MEMORANDUM

TO: Advisory Board on Radiation and Worker Health, Work Group on Carborundum Company
FROM: Robert Anigstein
DATE: November 27, 2018
SUBJECT: Audit of NIOSH Assessment of External Doses from Plutonium Fuel Pellets

Review of NIOSH White Paper

Figure 1. Glovebox Geometry Used in NIOSH MCNP Analysis (scales in cm)

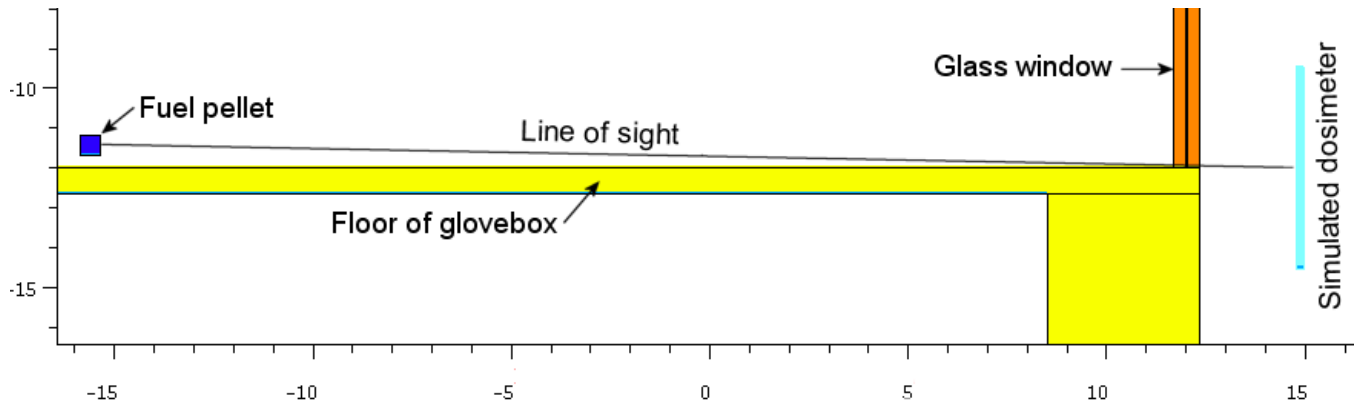
After the source bias was removed, the point detector (type 5) tallies at 1 ft and 1 m were 59% and 15% higher, respectively, than the corresponding type 4 tallies that were based on track lengths in simulated dosimeters. The cause was the exposure geometry, which is illustrated in Figure 1. As shown in the figure, the fuel pellet is only 1/8 inch above the floor of the glovebox. The simulated dosimeter, which measures 2 x 2 inches in the vertical plane and is 2 mm thick, is centered on the bottom surface of the glovebox. As shown by the line-of-sight drawn from the center of the fuel pellet to the dosimeter that just clears the edge of the glovebox floor, almost one-half of the dosimeter is effectively shielded from the source by the floor. In contrast, the point detector, which is located at the center of the dosimeter, is in full view of the pellet, except for the intervening glass window. The dosimeter at a distance of 1 m (not shown in the figure), is more exposed to the source, since the sloping line of sight would intercept it further below its

center. This helps explain the large discrepancy between the two tallies at 1 ft and the smaller discrepancy at 1 m.

Finding 3. The simulated dosimeters in the glovebox geometry modeled by NIOSH are partially shielded by the floor of the glovebox, which reduces the calculated doses.

We propose a change to the exposure geometry that would resolve this anomaly, as well as constituting a more realistic model of the gloveboxes used at Carborundum. Figure 2 shows some of the gloveboxes used in the plutonium research facility at Carborundum (Saulino et al. 1962a). As shown in the figure, each glovebox has two ports in which the worker inserts his hands. The plutonium would most likely have been positioned at the level of the center of the ports, perhaps halfway in between them. By scaling the elevation of the centers of the ports in the figure to the 3-ft average height of the glovebox (Saulino et al. 1962b), we estimate that the ports were 24 cm above the floor. We therefore revised the MCNP input file to place the center of the fuel pellet 24 cm above the glovebox floor, and placed both the point detectors and the centers of the simulated dosimeters at the same elevation. The resulting analysis of $H^*(10)$ photon doses from ^{241}Am showed that the results of the type 5 point detector tally at a distance of 1 ft from the pellet agreed with the results of the type 4 simulated dosimeter tally within 1.5%. This constitutes reasonable agreement, given the finite size of the dosimeter and the fact that the combined relative statistical uncertainty was 0.5%. The two tallies at 1 m agreed within 0.6%, while the combined relative statistical uncertainty was 1.4%. We thus believe that either type tally produces valid results if the fuel pellets are elevated well above the floor of the glovebox. The $H^*(10)$ photon doses from ^{241}Am based on type 4 tally results at distances of 1 ft and 1 m at the level of the glovebox floor are 45% and 21%, respectively, lower than the doses calculated at an elevation of 24 cm above the floor.
